# Access Compliance Report

## Public Rights-of-Way

### (Island Curb Cuts)

Intersection ID: 5600	Main Street: N_TRYON_ST	Cross Street: J_M_KEYNES_DR	Location: NE
ADA ID: 5ABE23763669	Curb Cut Type: MedianRefuge2	Initial Pass/Fail: Pass	Overall Compliance: No
Severity Score: 0			
Codes/Mitigation Info/Possible Solution		Field Measurements/Component Compliance

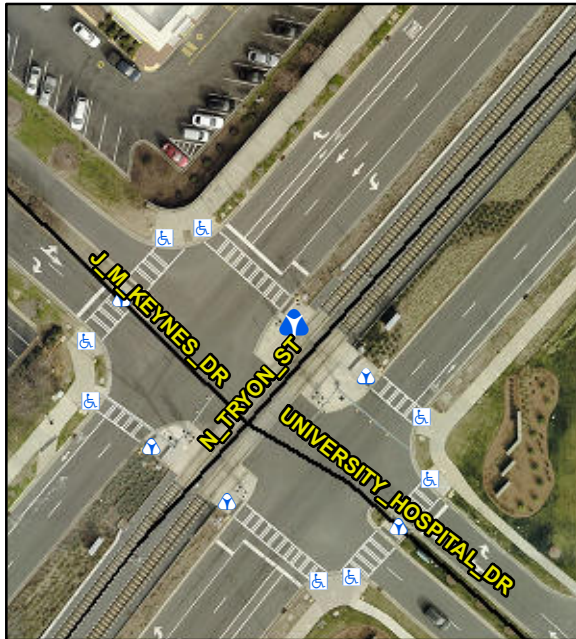
Compliance	Description	Data	Compliance	Description	Data
Yes	Refuge 1 Length (In)	48.0	Yes	Gutter 1 Ponding?	No
Yes	Refuge 1 Width (In)	120.0	Yes	Gutter 1 Lip Ht (In)	0.0
Yes	Refuge 1 Slope (%)	0.2	Yes	Gutter 1 Slope (%)	2.1
Yes	Refuge 1 X Slope (%)	0.2	Yes	Gutter 1 X Slope (%)	0.0
N/A	Painted X Walk1?	Yes	Yes	DWS 1 Provided?	Yes
N/A	X Walk 1 Direction	To NE	Yes	DWS 1 Contrast?	Yes
N/A	X Walk 1 Width (In)	99.0	No	DWS 1 Length (In)	23.5
N/A	Road 1 Slope (%)	0.3	Yes	DWS 1 Full Width?	Yes
N/A	Road 1 X Slope (%)	2.5	Yes	DWS 1 Offset (In)	1.0
Yes	Refuge 2 Length (In)	48.0	Yes	Gutter 2 Ponding?	No
Yes	Refuge 2 Width (In)	120.0	Yes	Gutter 2 Lip Ht (In)	0.0
Yes	Refuge 2 Slope (%)	0.9	Yes	Gutter 2 Slope (%)	1.3
Yes	Refuge 2 X Slope (%)	0.6	Yes	Gutter 2 X Slope (%)	0.6
N/A	Painted X Walk2?	No	Yes	DWS 2 Provided?	Yes
N/A	X Walk 2 Direction	To S	Yes	DWS 2 Contrast?	Yes
N/A	X Walk 2 Width (In)	N/A	No	DWS 2 Length (In)	23.5

N/A	Road 2 Slope (%)	1.1	Yes	DWS 2 Full Width?	Yes
N/A	Road 2 X Slope (%)	2.4	Yes	DWS 2 Offset (In)	1.0
N/A	Refuge 3 Length (in)	N/A	N/A	Gutter 3 Ponding?	N/A
N/A	Refuge 3 Width (in)	N/A	N/A	Gutter 3 Lip Ht (in)	N/A
N/A	Refuge 3 Slope (%)	N/A	N/A	Gutter 3 Slope (%)	N/A
N/A	Refuge 3 XSlope (%)	N/A	N/A	Gutter 3 XSlope (%)	N/A
N/A	Painted X Walk3?	N/A	N/A	DWS 3 Provided?	N/A
N/A	X Walk 3 Direction	N/A	N/A	DWS 3 Contrast?	N/A
N/A	X Walk 3 Width (in)	N/A	N/A	DWS 3 Length (in)	N/A
N/A	Road 3 Slope (%)	N/A	N/A	DWS 3 Full Width?	N/A
N/A	Road 3 XSlope (%)	N/A	N/A	DWS 3 Offset (in)	N/A
Yes	Any Obstructions?	No	N/A	Storm Grate/Utility Hazard?	No
N/A	Obstruction Type		N/A	Storm Grate/Utility Type	
		N/A			N/A
N/A	Surface Condition	Good

**Remove & Replace Detectable Warning System.**
